METROPOLITAN GOVERNMENT OF NASHVILLE AND DAVIDSON COUNTY

STAFF RECOMMENDATION
2006 Beechwood Avenue
March 19, 2014

Application: Demolition—outbuilding; New construction—outbuilding; Setback determination

District: Belmont-Hillsboro Neighborhood Conservation Zoning Overlay

Figure 2 (left) shows the existing outbuilding and Figure 3 (right) shows the 1957-61 Sanborn Map

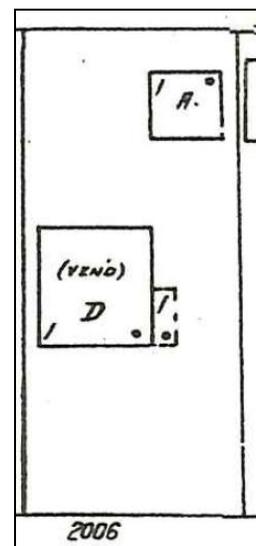
Demolition: The applicant is proposing to demolish an existing outbuilding (Figure 2). The outbuilding may be the same structure that appears on the 1957-61 Sanborn Map (Figure 3). However, the existing outbuilding lacks historic and architectural significance, and its demolition will not adversely affect the historic character of the site or the Belmont-Hillsboro Neighborhood Conservation Zoning Overlay. Staff therefore finds that the project meets section III.B.2 for appropriate demolition and does not meet section III.B.1 for inappropriate demolition.

A1 SITE PLAN
1/16" = 1'-0"

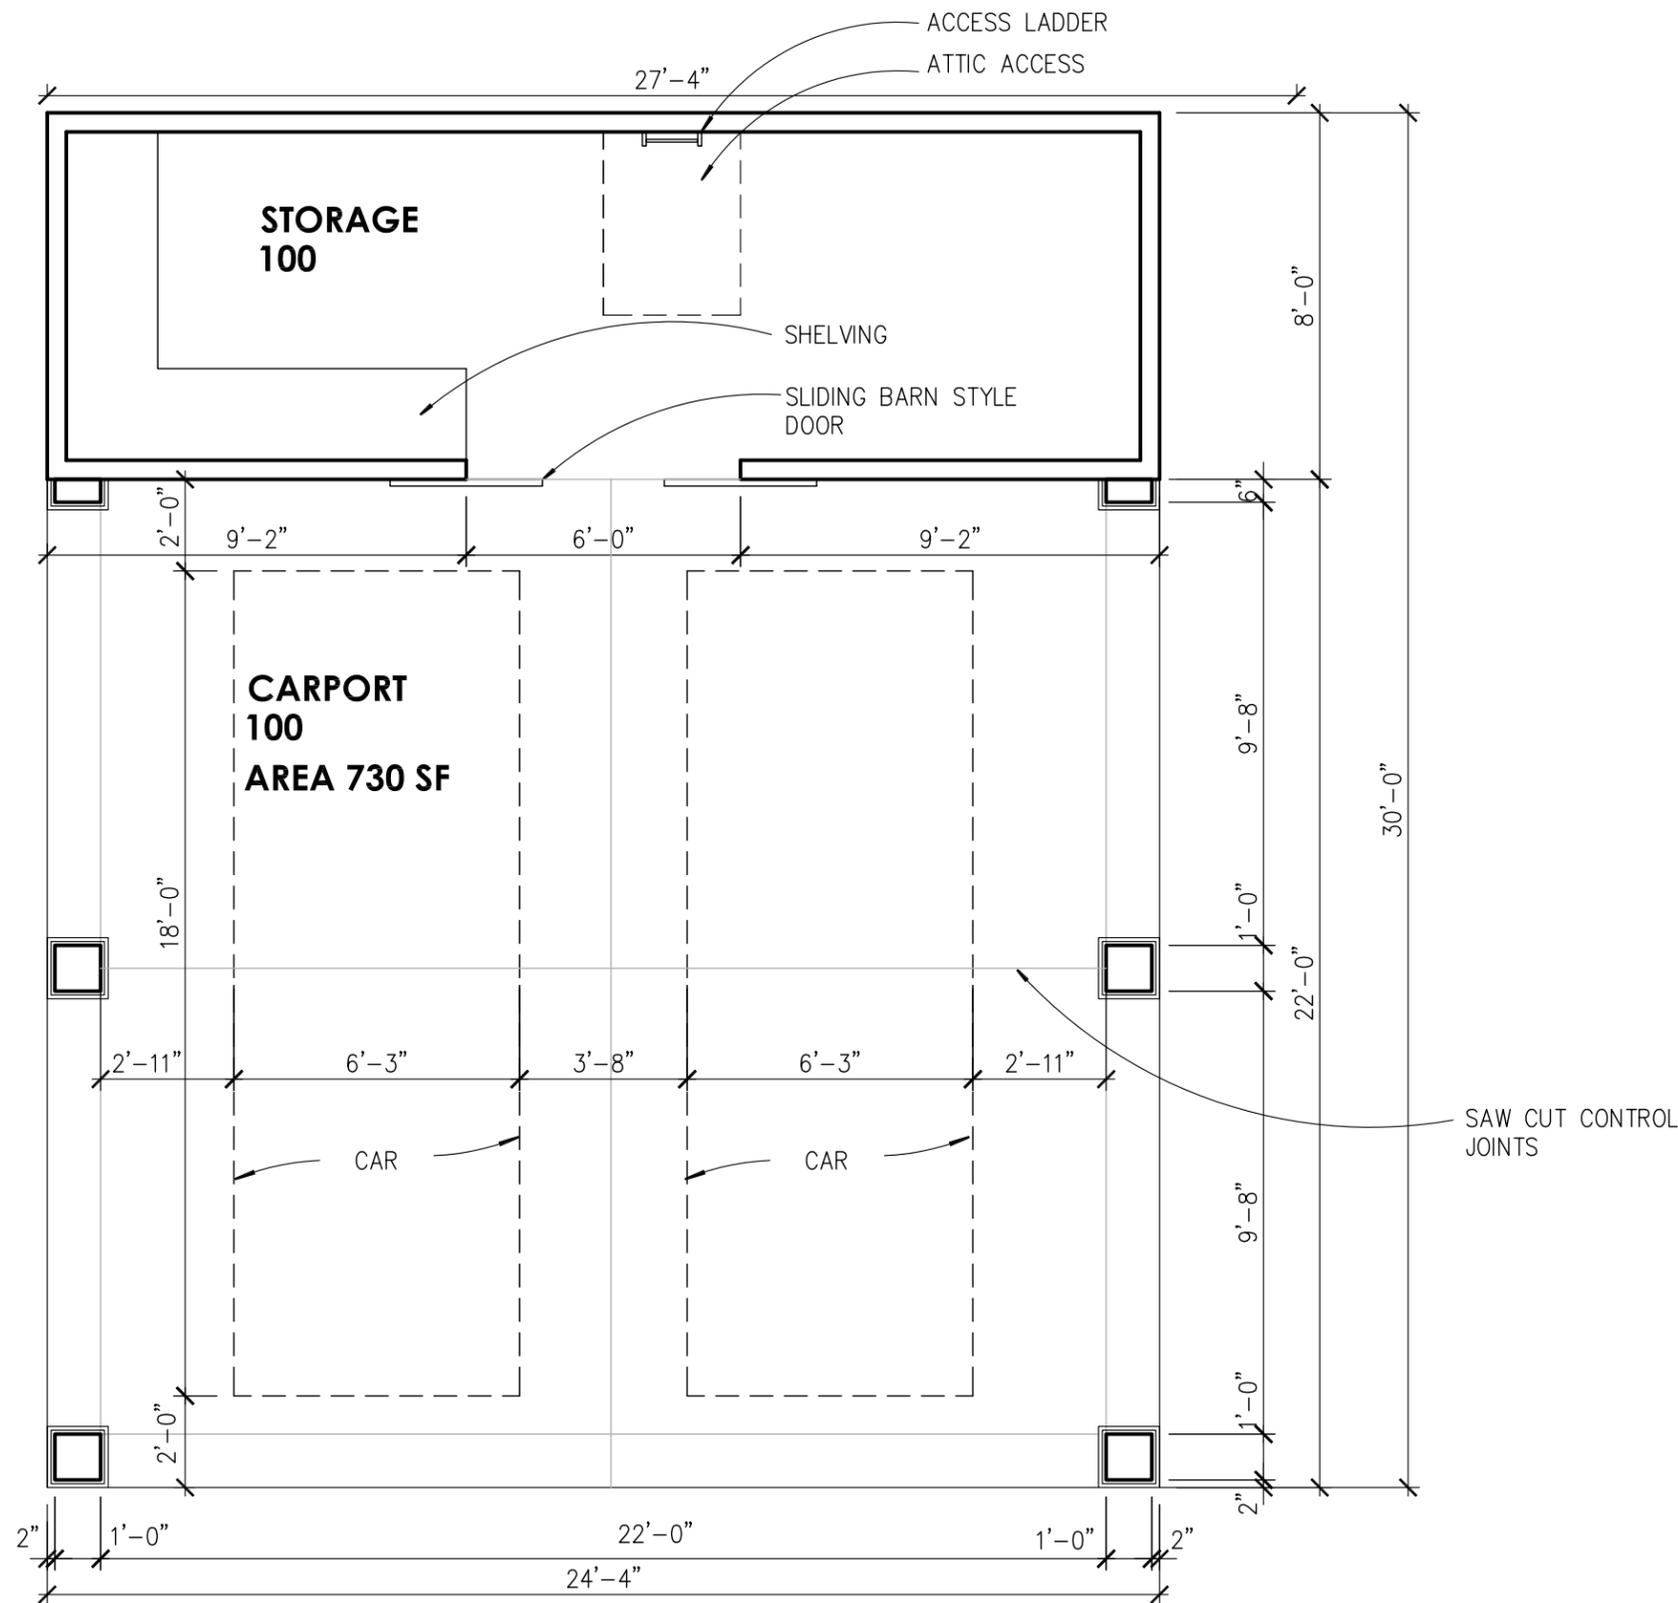
Setback & Rhythm of Spacing: The outbuilding is to be constructed behind the historic house, in the rear yard, which is appropriate. Because the proposed building has a footprint greater than seven hundred square feet (700 sq. ft.), base zoning requires that the outbuilding be placed a minimum of twenty feet (20') from the rear property line and five feet (5') from the side property lines. The applicant is requesting a setback determination for the right side and the rear. The applicant proposes to locate the outbuilding three feet (3') from the right side property line and thirteen feet (13') from the rear property line. Staff finds the proposed setbacks to be appropriate for several reasons. The existing accessory structure is located just a little less than three feet (3') from the side property line, and therefore the new outbuilding, which is largely an open carport, will not significantly alter the existing side setback. Also, an examination of the Metro Map shows that there are many outbuildings along Beechwood Avenue that sit closer than five feet (5') from the side property line and twenty-feet (20') from the rear property line. In fact, outbuildings like this one historically were located close to the rear and the side property lines. Staff finds that the proposed outbuilding meets sections II.B.1.c. and II.B.1.i. of the design guidelines.

E1 FRONT ELEVATION
 1/4" = 1'-0"

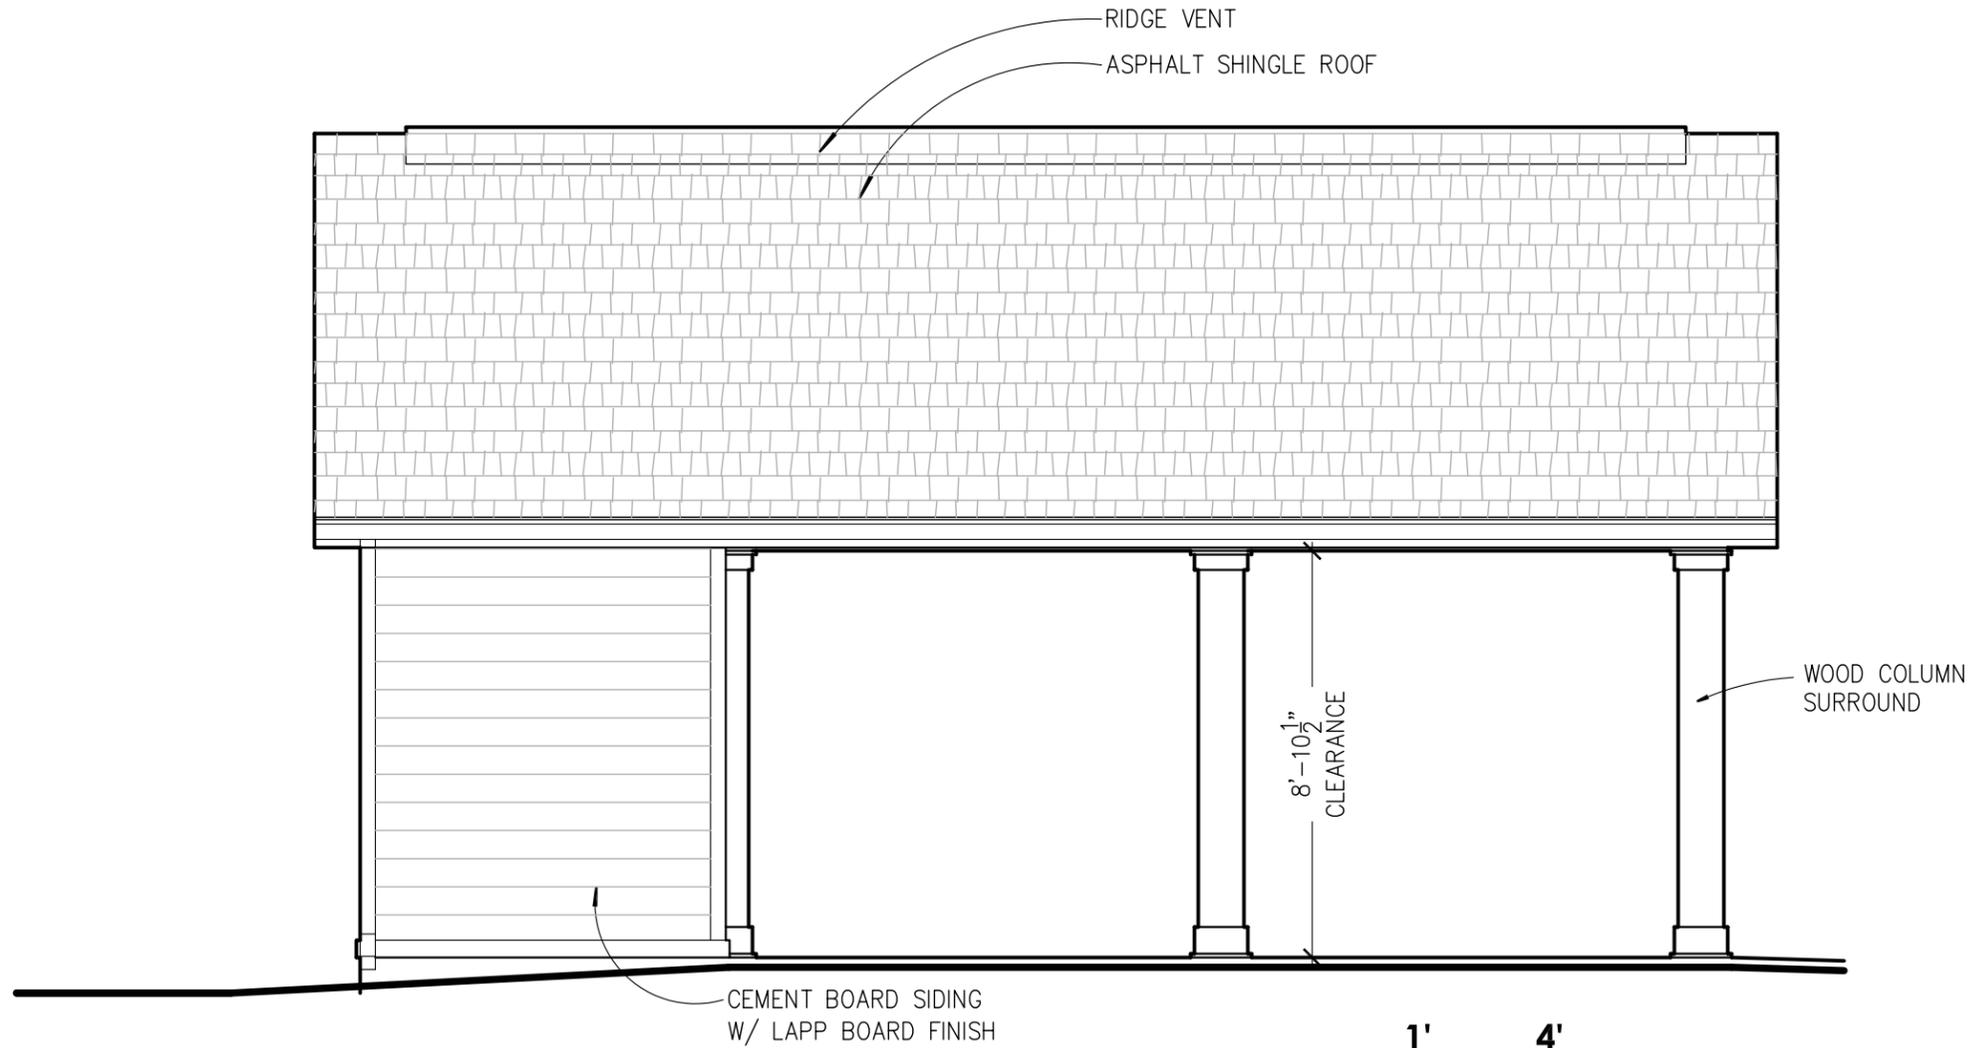
Roof form: The outbuilding will have a front-gabled roof with a slope of 8/12. Staff finds that this roof form is compatible with the primary structure and with the surrounding historic context. Staff therefore finds that the roof form meets sections II.B.1.e. and II.B.1.i. of the design guidelines.

Proportion and Rhythm of Openings: The outbuilding will be a carport that is largely open in nature. The only opening proposed for the enclosed portion of the outbuilding is

a sliding barn-door style door opening. Staff finds that the proportion and rhythm of openings are appropriate for an outbuilding and meet sections II.B.1.g. and II.B.1.i. of the design guidelines.

1. The cement fiberboard siding be smooth faced and have a maximum reveal of five inches (5");
2. Staff review and approve the asphalt shingle color and the door selection prior to purchase and installation.
